ADDENDUM# 3

**University of Kentucky
2555.0 Delta Gamma House New Construction**

Addendum #03

Written Questions and Answers

DWG. NO.
P402

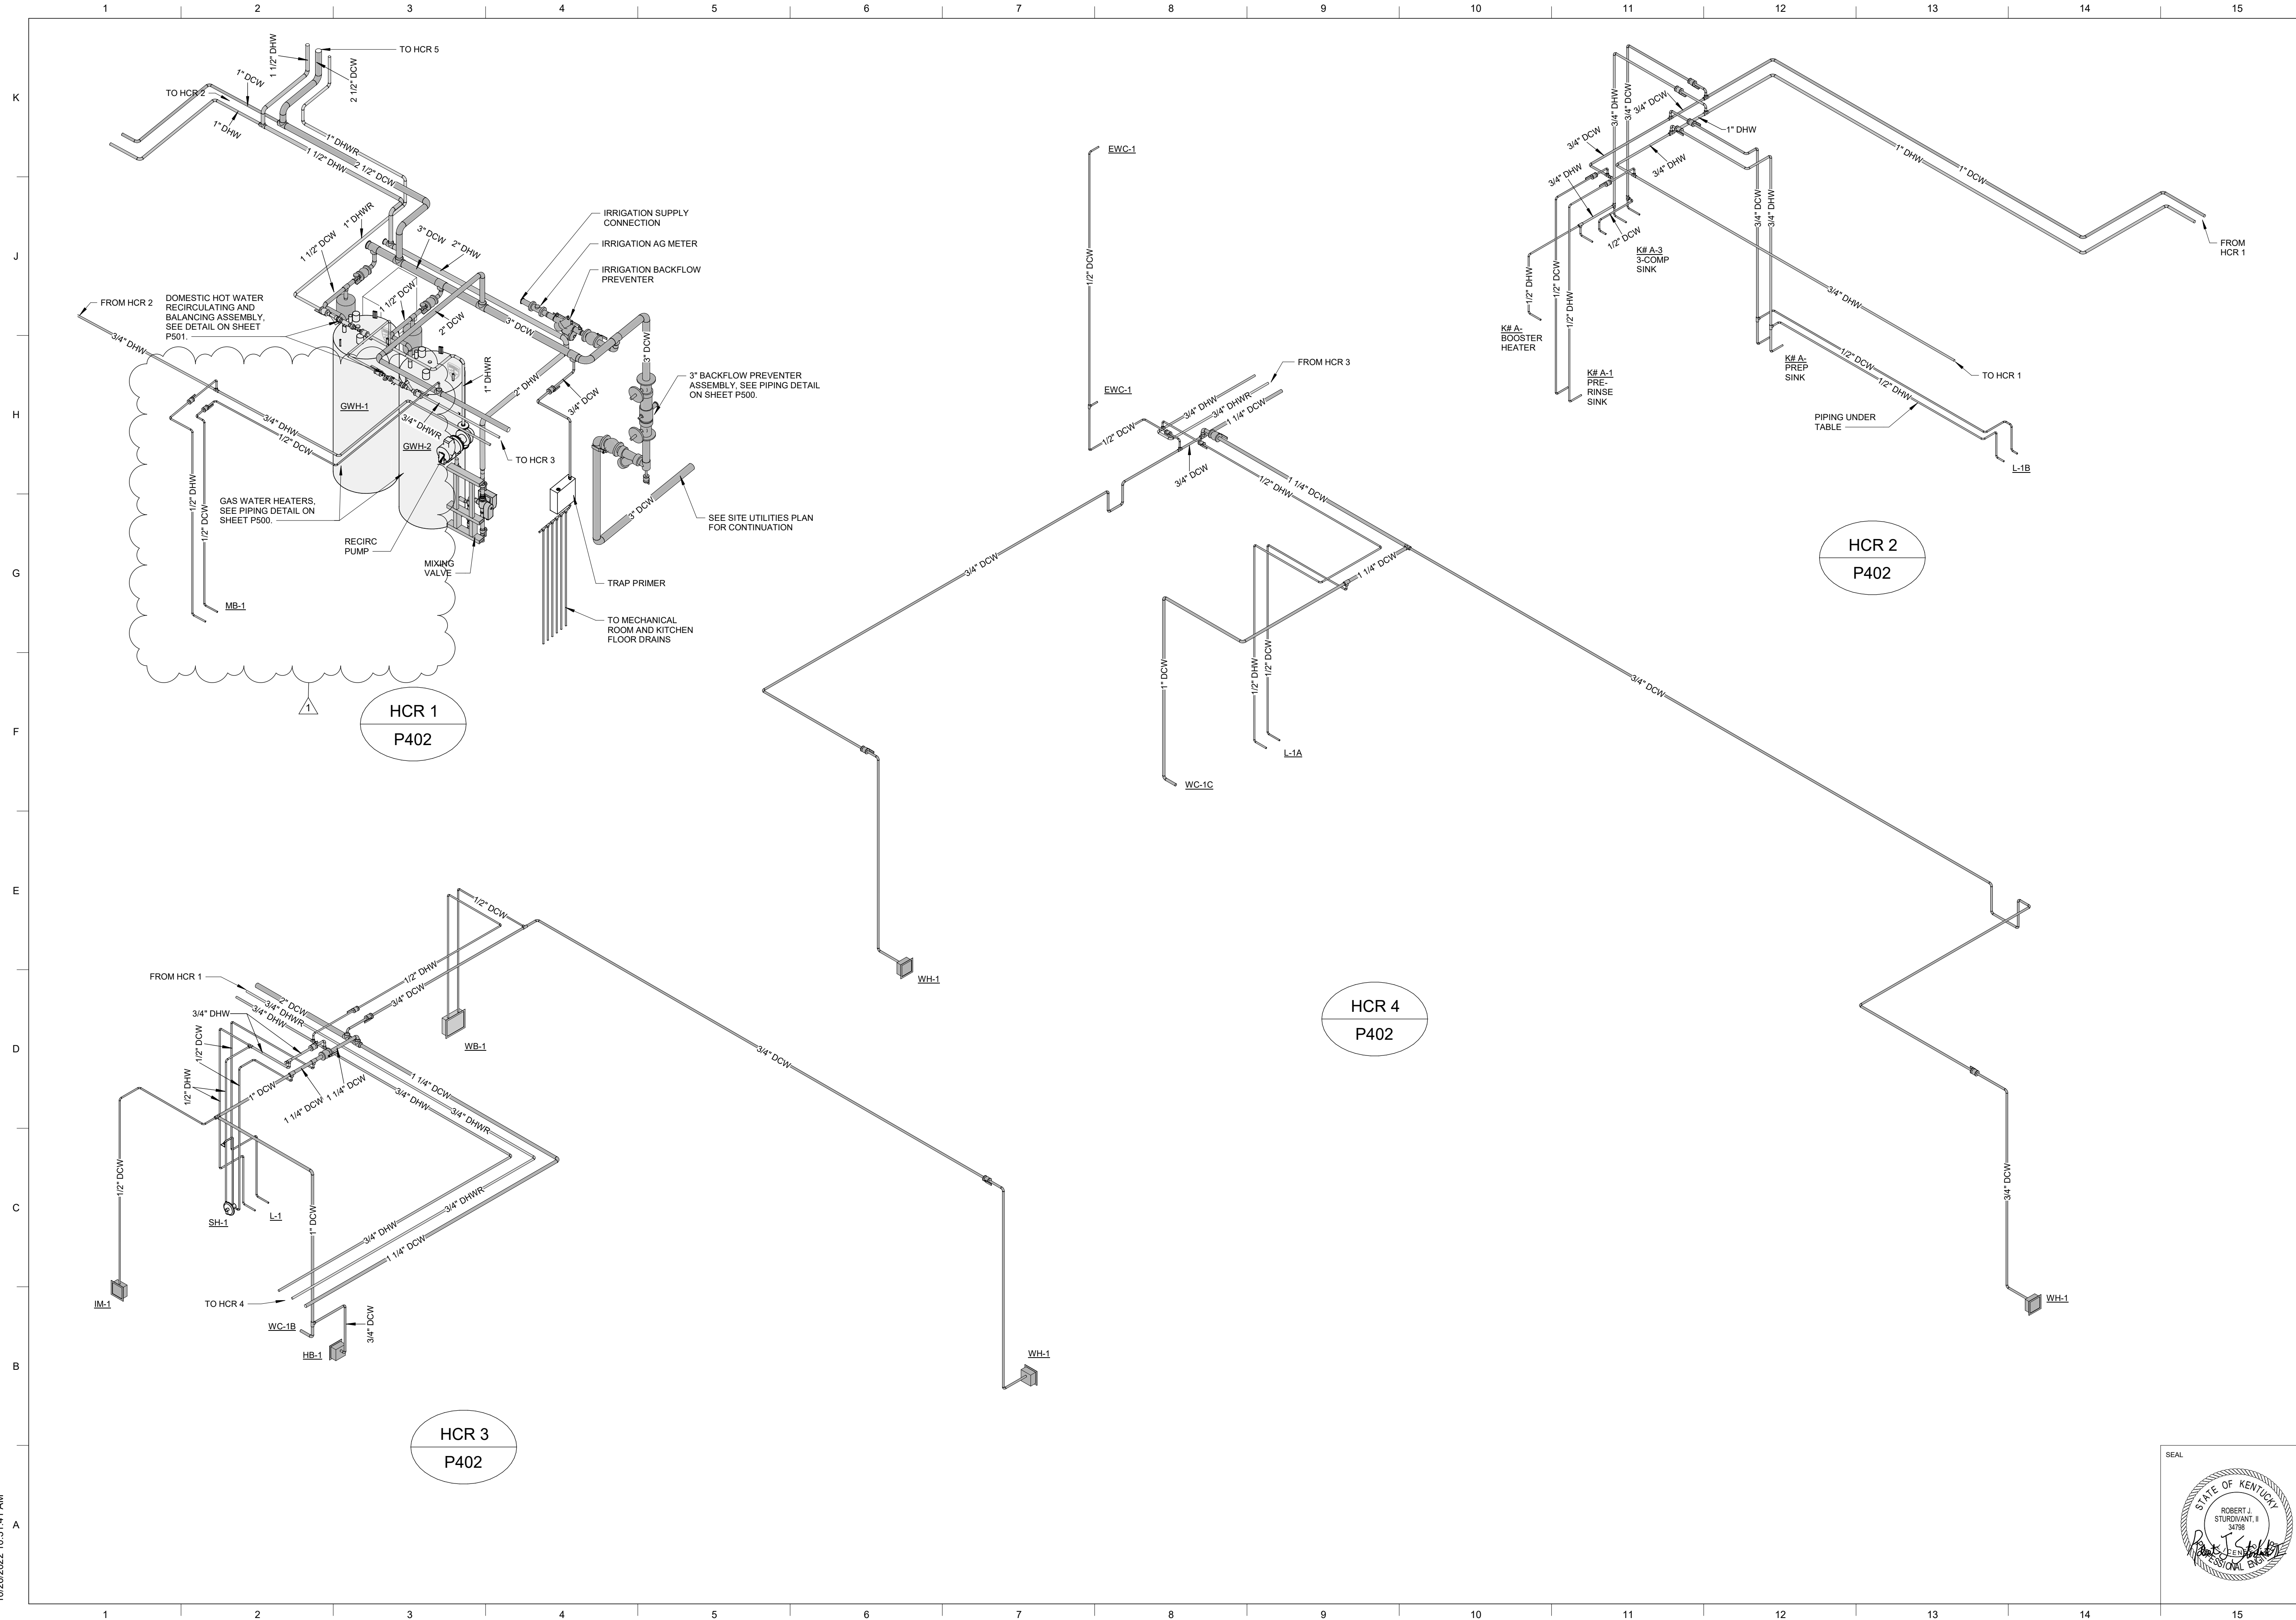
LH102	SITE PLAN – ALTERNATE #1	10/26/22
	<ul style="list-style-type: none">• Material update to remove pavers.	
LH201	LAYOUT PLAN	10/26/22
	<ul style="list-style-type: none">• Material update to remove pavers.	
LH202	LAYOUT PLAN – ALTERNATE #1	10/26/22
	<ul style="list-style-type: none">• Material update to remove pavers.	
P001	UNDERFLOOR PLUMBING PLAN	10/26/22
	<ul style="list-style-type: none">• Add mop basin in Dry Storage Rm 134A per Jurisdiction Review	
P101	SANITARY WASTE AND VENT PLUMBING PLAN – LEVEL 01	10/26/22
	<ul style="list-style-type: none">• Add mop basin in Dry Storage Rm 134A per Jurisdiction Review	
P201	DOMESTIC WATER PLUMBING PLAN – LEVEL 01	10/26/22
	<ul style="list-style-type: none">• Add mop basin in Dry Storage Rm 134A per Jurisdiction Review	
P400	PLUMBING RISERS	10/26/22
	<ul style="list-style-type: none">• Add mop basin in Dry Storage Rm 134A per Jurisdiction Review	
P402	PLUMBING RISERS	10/26/22

<ul style="list-style-type: none">• Add mop basin in Dry Storage Rm 134A per Jurisdiction Review	
P500	PLUMBING DETAILS AND SCHEDULES	10/26/22
	<ul style="list-style-type: none">• Add mop basin in Dry Storage Rm 134A per Jurisdiction Review	
U101	SITE UTILITIES PLAN	10/26/22
	<ul style="list-style-type: none">• Revised Note 19.

P500

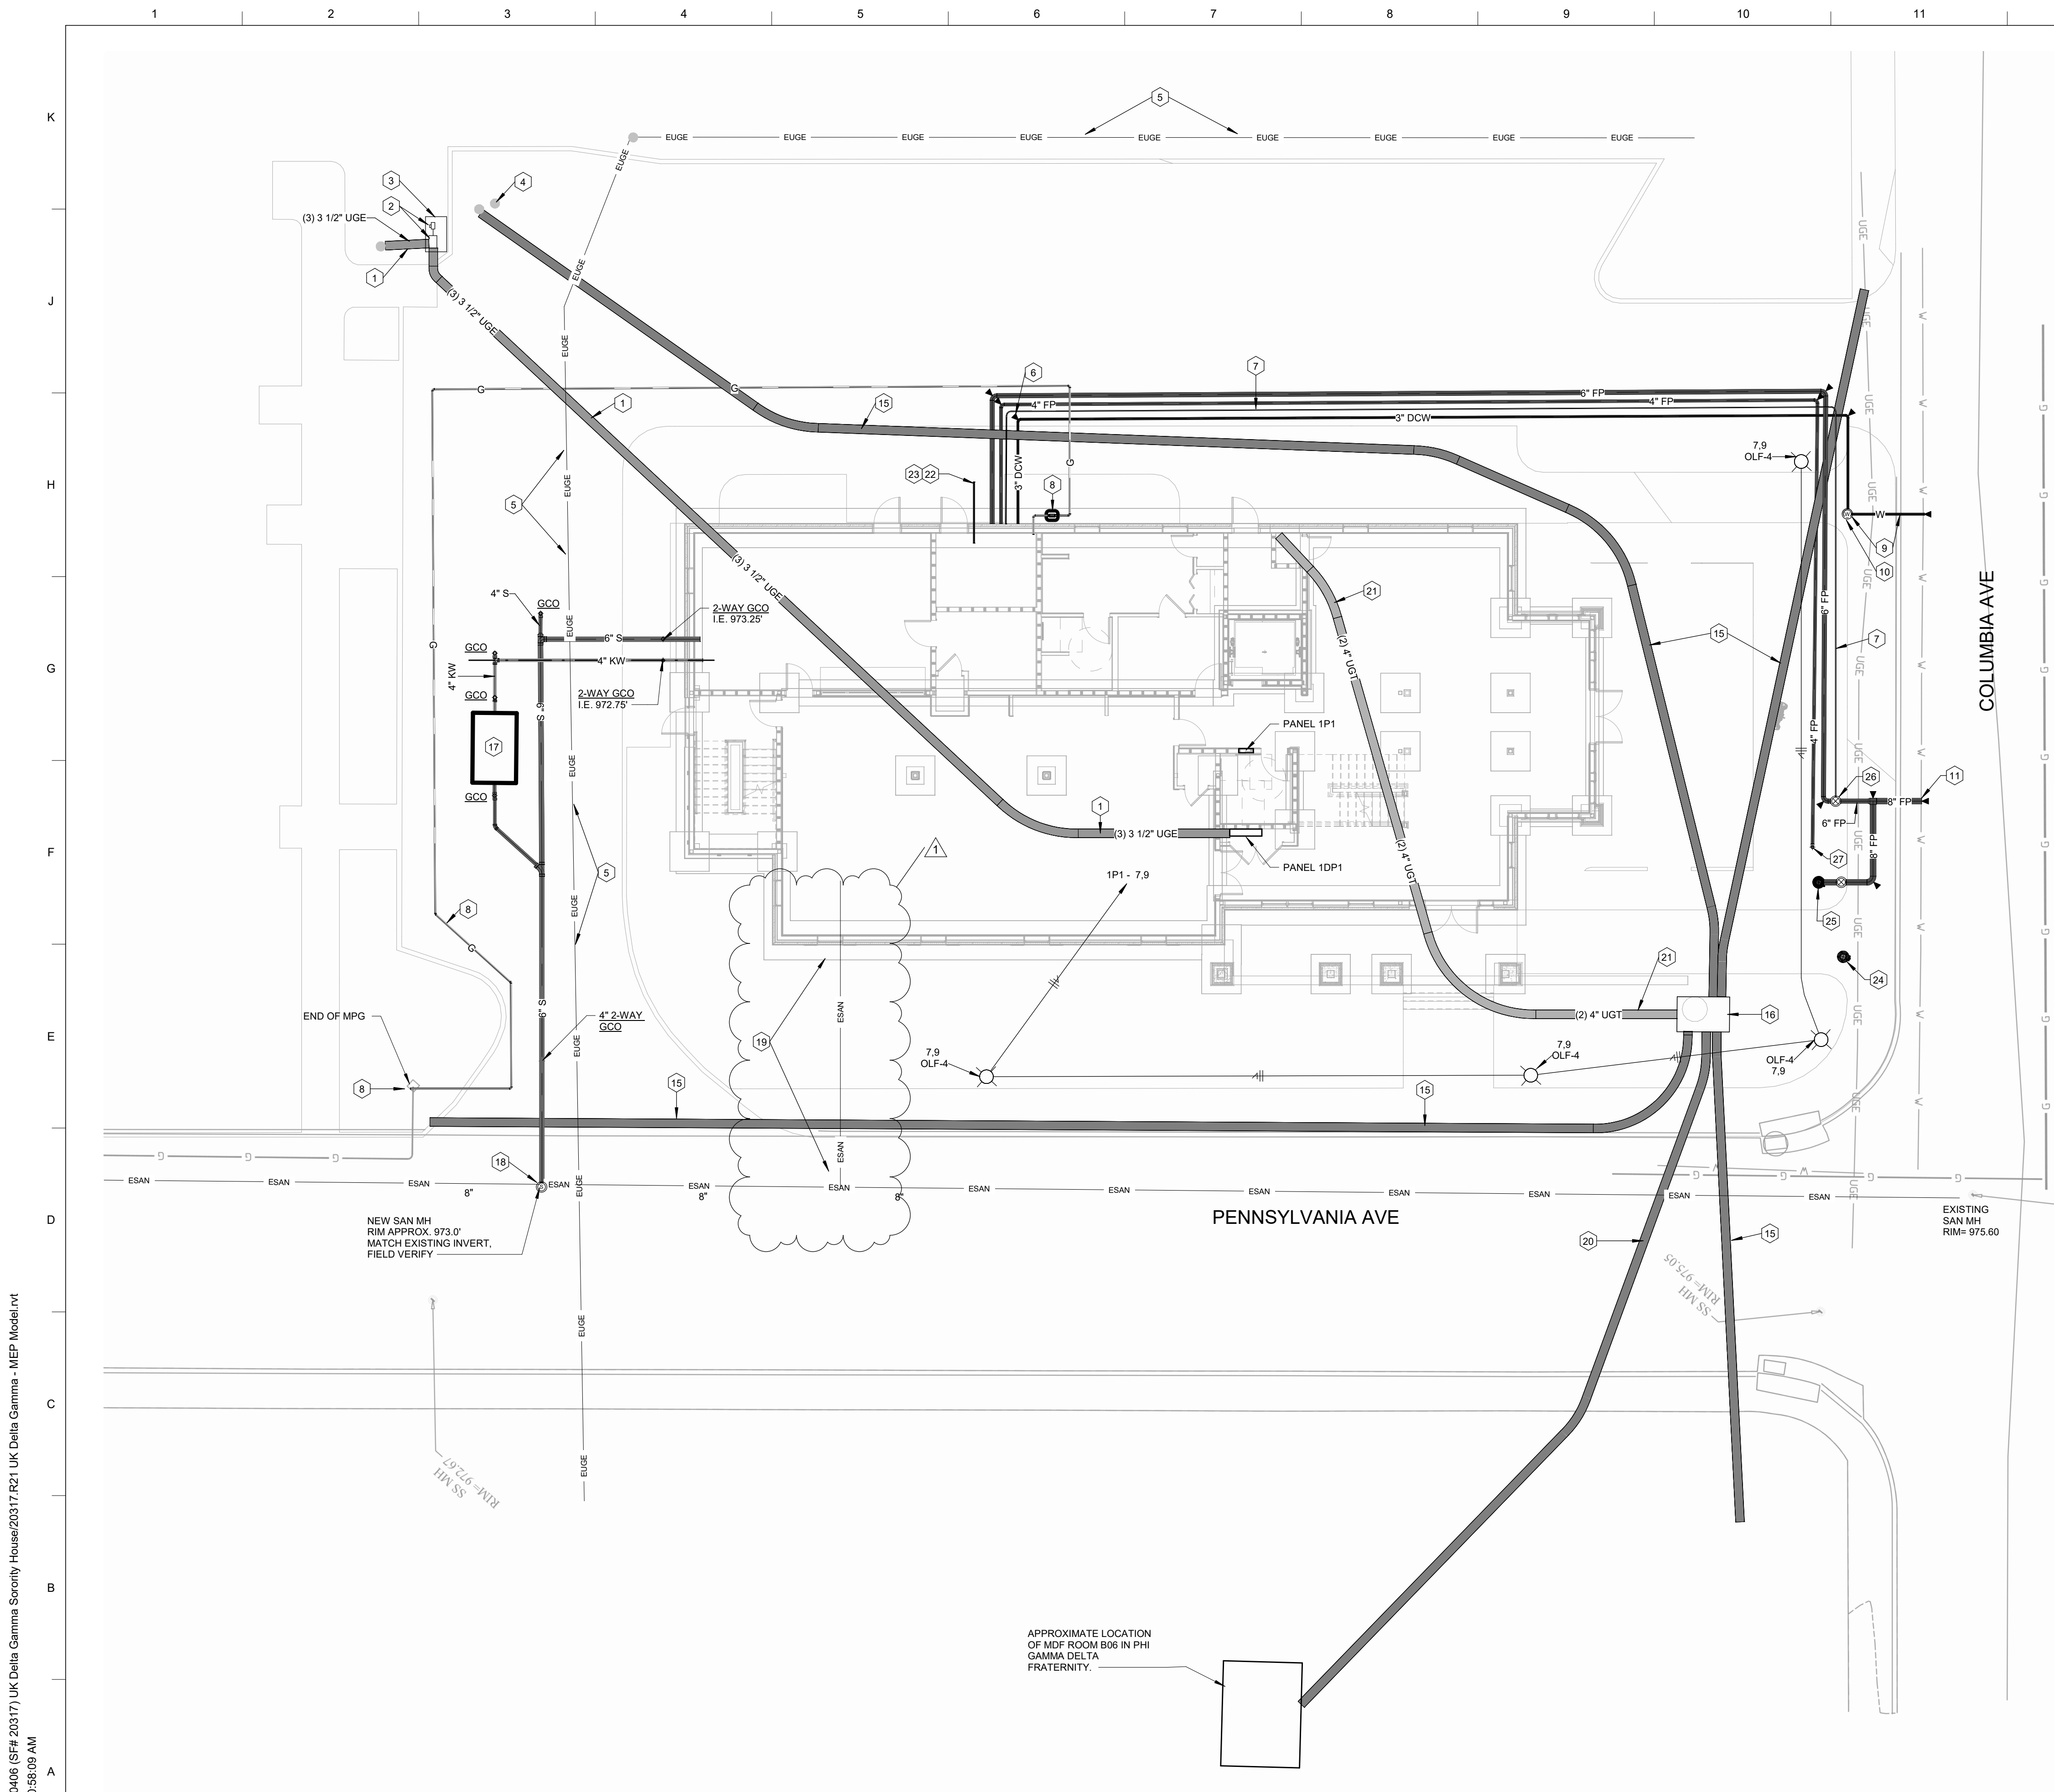
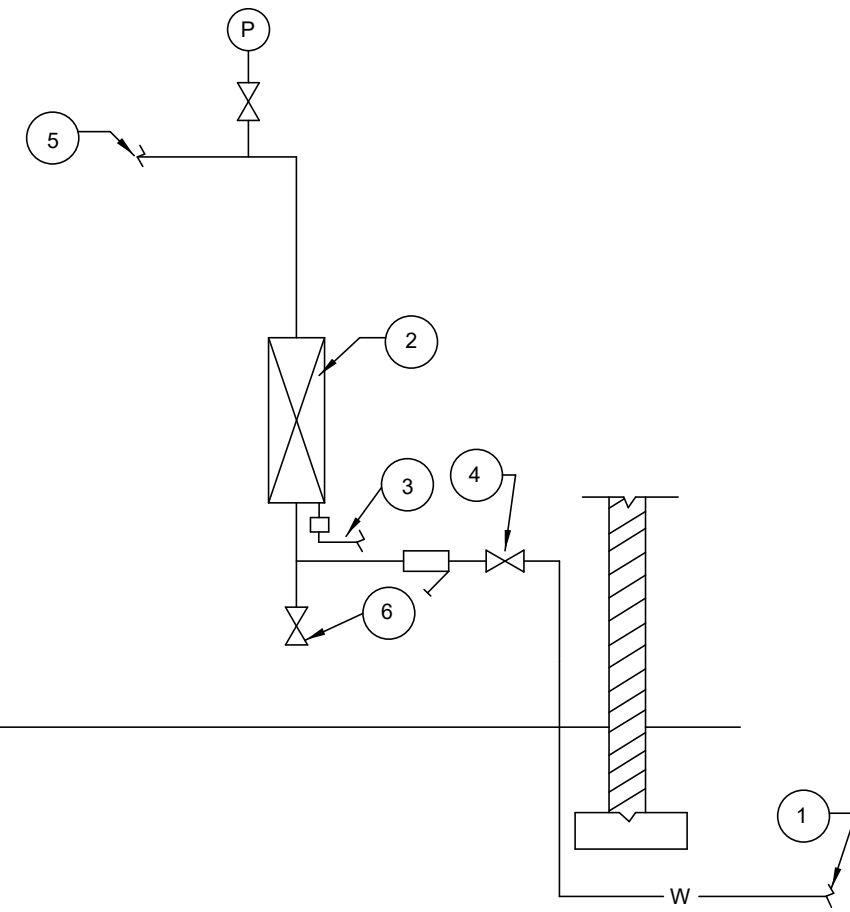
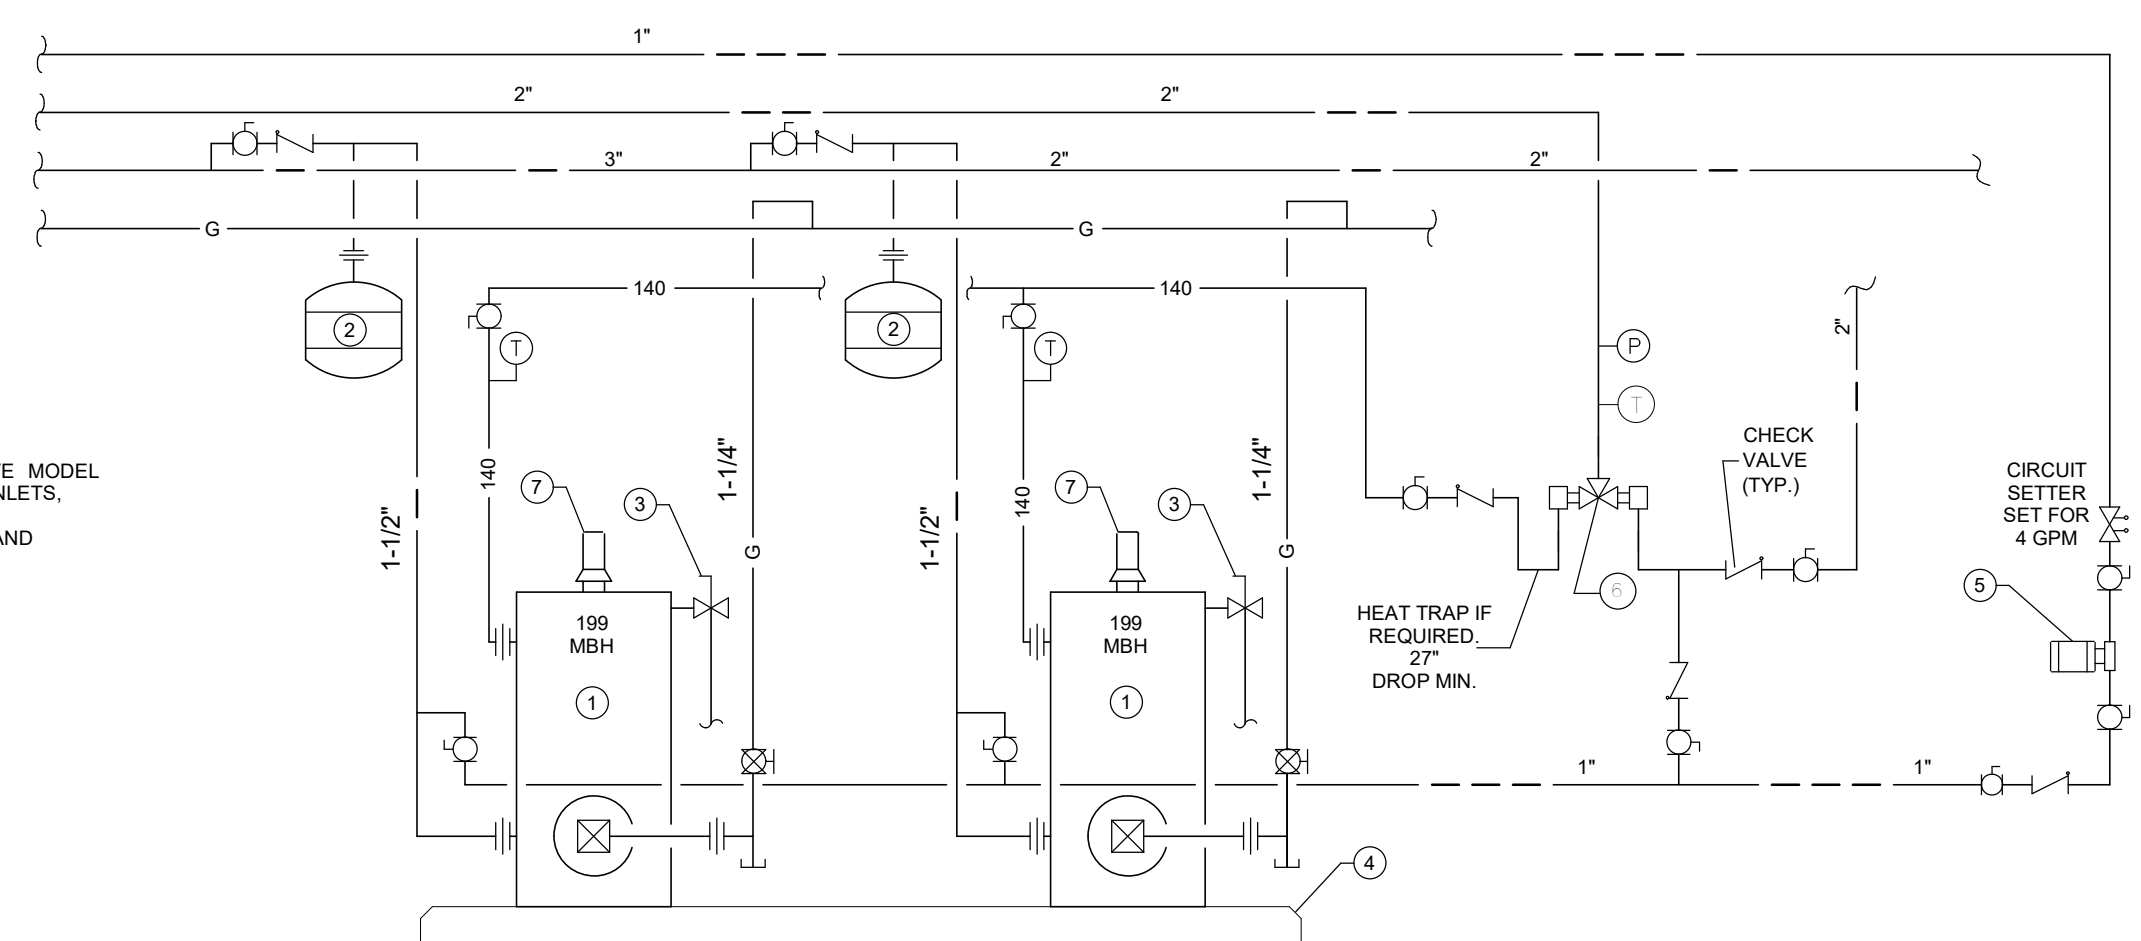
2.	Storm at line N has no size indicated, please advise.	Prime AE	See detail SD1, 12" line
3.	Drawing U101, Note 19 reads - EXISTING SANITARY SERVICE LATERAL TO BE CUT AND CAPPED AT MAIN AND AT BLDG ENTRANCE. PIPING MAY BE ABANDONED IN PLACE., no laterals shown and where does abandonment start and stop? Please advise.	KFI	Refer to EC1, Existing Conditions Plan.

4.	Drawing U101 - What size is the site NG? Please advise.	KFI	Natural Gas to gas meter will be by Columbia Gas.
5.	Can Sch 40 PVC DWV piping be used in lieu of Cast Iron piping and fittings Spec Section 22 13 16.	KFI	Not sure we fully understand the question, however, PVC may be used for sanitary piping – not for domestic water as the term “DWV” infers.

- EXISTING SANITARY SERVICE LATERAL TO BE CUT AND CAPPED AT MAIN AND AT BLDG ENTRANCE. PIPING MAY BE ABANDONED IN PLACE. REFER TO SHEET EX1, EXISTING CONDITIONS PLAN FOR EXISTING SITE UTILITIES NOT SHOWN.
